ASSESSMENT REPORT

WOOLOOWARE BAY TOWN CENTRE CONCEPT PLAN MP 10_0229 MOD 5

Figure 7: Area of Family Hill within the required 40 metre riparian corridor

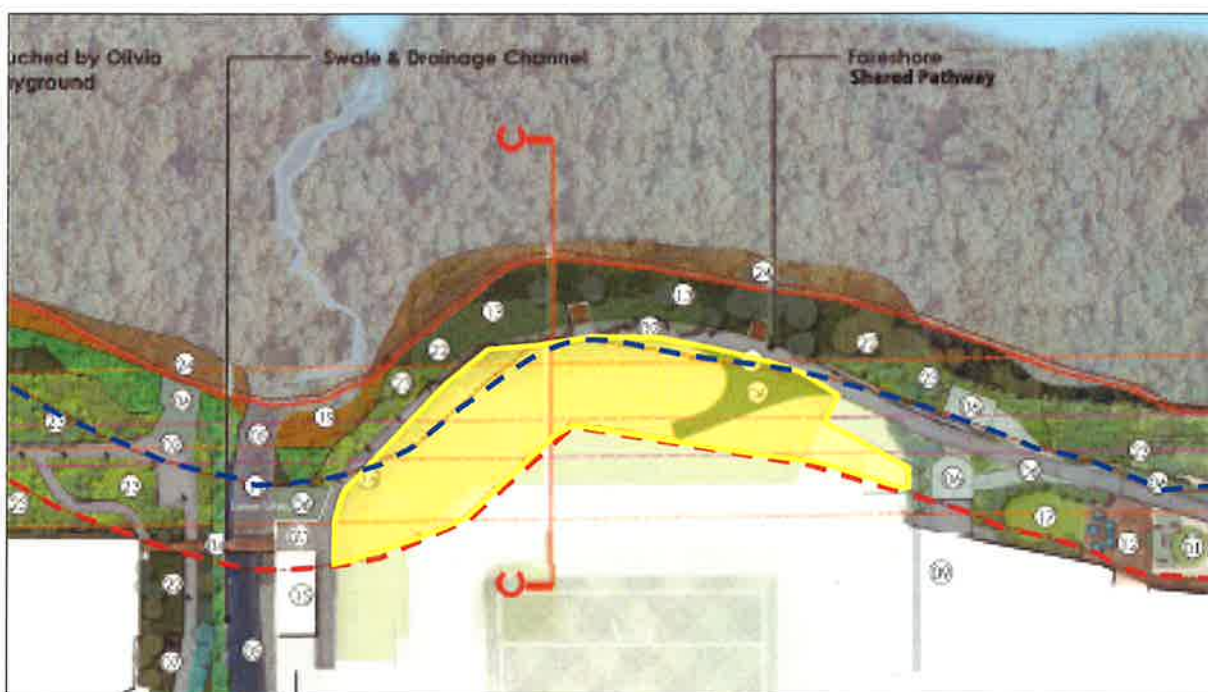
OEH objects to the proposal on the basis that it is inappropriate to exclude Family Hill from the riparian corridor without appropriate offsets elsewhere on the site. DPI also advises that if Family Hill is proposed to be retained for recreation, it should be offset elsewhere on the site.

The Department acknowledges that it was always envisaged to retain Family Hill in its current state. However, the Department notes the Concept Plan Approval applies to the entire site, including the existing stadium and Family Hill. Therefore, the Department considers it is appropriate to include Family Hill within the riparian corridor to ensure the potential impacts of the development across the entire site are fully assessed.

The Department considers the significant level of development across the wider site warrants an appropriate riparian buffer along the entire length of the waterfront. The Department, therefore, considers the NOW Guidelines should be applied to the entire waterfront setback area, and Family Hill be included within the VRZ for the purpose of calculating appropriate offsets.

Figure 8: Location of proposed offset planting

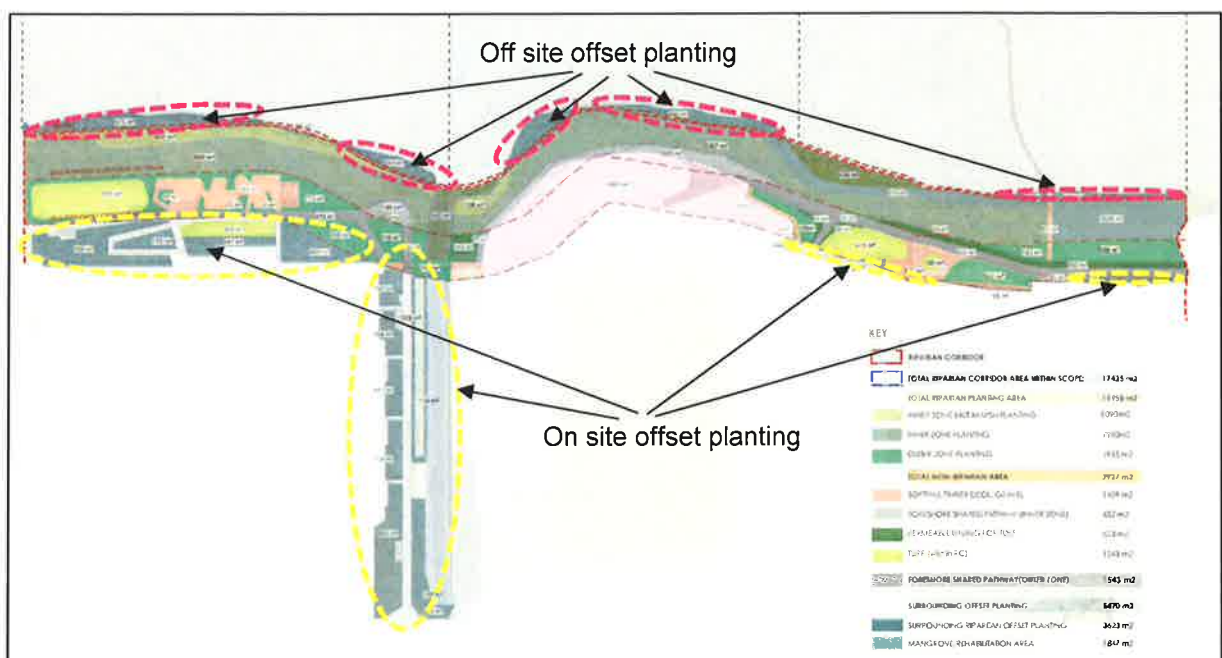
However, OEH and DPI raise concerns about the above proposed offset plantings:

- DPI advises that the Proponent has included vegetation adjacent to the drainage channel in the 3,722 m² offset, compared with the area surrounding the drainage channel which was approved with, and required a vegetated riparian corridor itself. The vegetated riparian corridor is in addition to the main corridor required along the northern boundary and cannot be included as offset for encroachments on the northern corridor.
- OEH and DPI advise that the proposed off-site should not be considered an offset as it is outside the development site, on land owned by RMS and, therefore, inconsistent with the NOW Guidelines, which require offsets to be provided on-site.

The Department agrees with DPI that the riparian corridor adjacent to the drainage channel is required in addition to the main riparian corridor and it is unreasonable to consider it as an offset for encroachments on the main riparian corridor. Riparian planting in this part of the site equates to 1,946 m², so that, effectively only 1,776 m² of on-site planting is provided to offset encroachments on the main 40 metre corridor.

Applying the NOW Guidelines, the Department concludes that the proposal requires offset planting of 7,146 m², but it only incorporates 1,776 m² of on-site offset planting. The proposed non-riparian works would, therefore, not be offset in accordance with the NOW Guidelines, and would potentially result in a diminished outcome for the adjoining wetlands and TPAR compared with the Concept Plan Approval and current standards. Given the proposed works have not been offset in accordance with the NOW Guidelines, the Department has assessed the merits of the proposed non-riparian uses below.
